# Interaction Region Mechanics Overview

20<sup>th</sup> KEBK Accelerator Review Committee

KEK, 23-25 February 2015

## 19<sup>th</sup> KEKB Accelerator Review Committee Report

# Findings and comments (Pressure of IR)

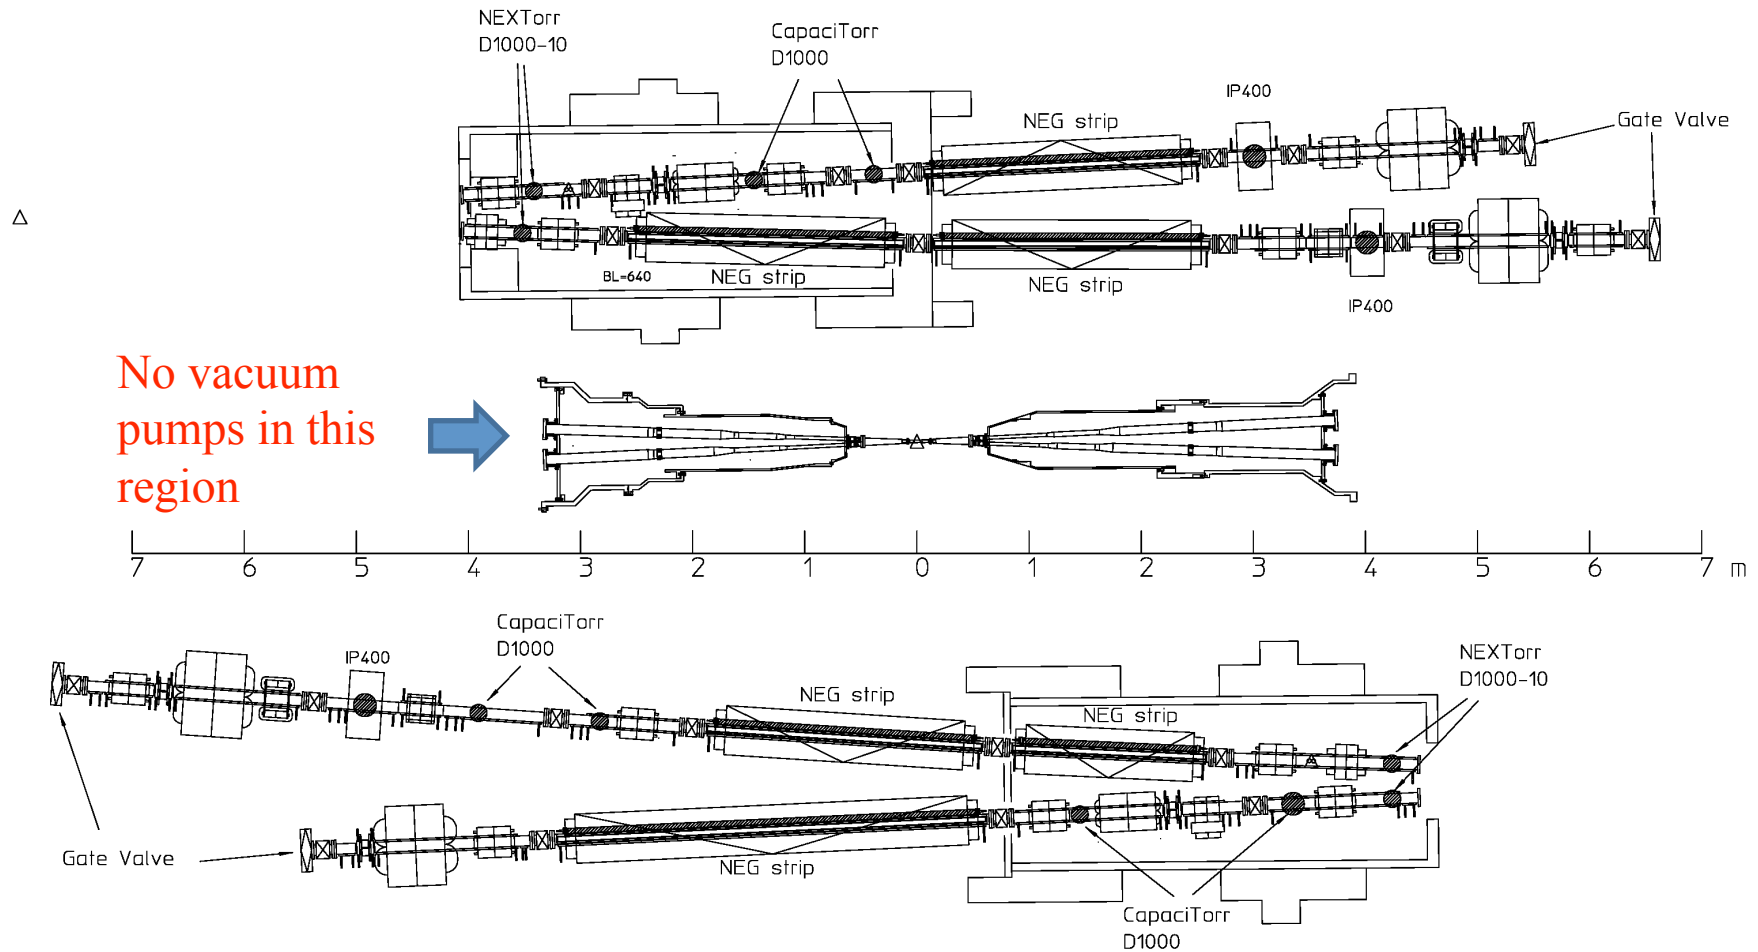
There is no vacuum pumping over +/-4 m as agreed to by the Belle II detector as there is no space for internal or external pumps. The potential use of a vacuum simulation code is recommended to predict the vacuum profile in the IR region. This would be a good task for a young vacuum person leading to an optimized choice of vacuum pumping outside the IR beyond 4 m. The calculation of the pressure profile during the scrubbing phase profile is also very important to predict the validity of the concrete shielding. The simulation should take into account also methane degassing: the nearest pump to the interaction point has a very low pumping speed for CH<sub>4</sub>. The indication that 'the average pressure in the IR region will be 10<sup>-6</sup> Pa or higher' should be further investigated in detail with the hope of understanding the maximum pressure and making it as low as possible and consistent with Belle II operation. (See the next slide)

New calculations of the expected vacuum pressures in the IR should be completed including the new chamber geometry, surfaces, and beam conditions.

I agree the importance to investigate a pressure profile near IP. I made contact with R. Kersevan and M. Ady. I also attended the Molflow seminar by M. Ady held at KEK. We agreed to study somewhat simplified IR model. However, I have not yet prepared necessary data, because of the complexity of IR geometry. I think we should get some results until Phase 2 (not an urgent issue).

## Findings and comments (Electron cloud in IR)

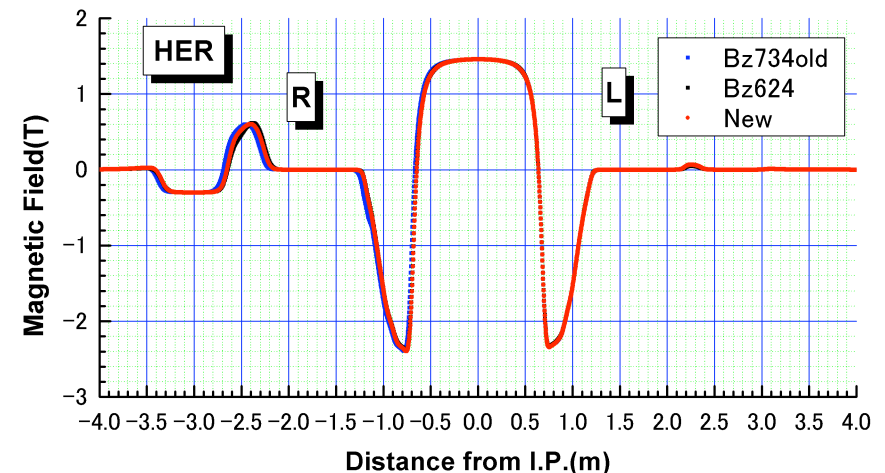
In the present design, there is **no TiN coating in the IR region**. It is not clear if scrubbing would be as efficient as in the rest of the accelerator. It is also not clear where solenoids could be installed in case electron cloud appeared in the IR chambers.

### Reply:

For Phase 1, all positron beam pipes are TiN coated. Since the stored current at Phase 1 is 0.5 – 1 A. This is sufficient.

For later Phases, there is always a certain kind of magnetic fields. If we see a solenoid component, it is strong enough to suppress the cloud. However, simulation under the real complicated field pattern will be necessary to estimate a real density of the cloud. The effect of the cloud in a large beta-function region is large.
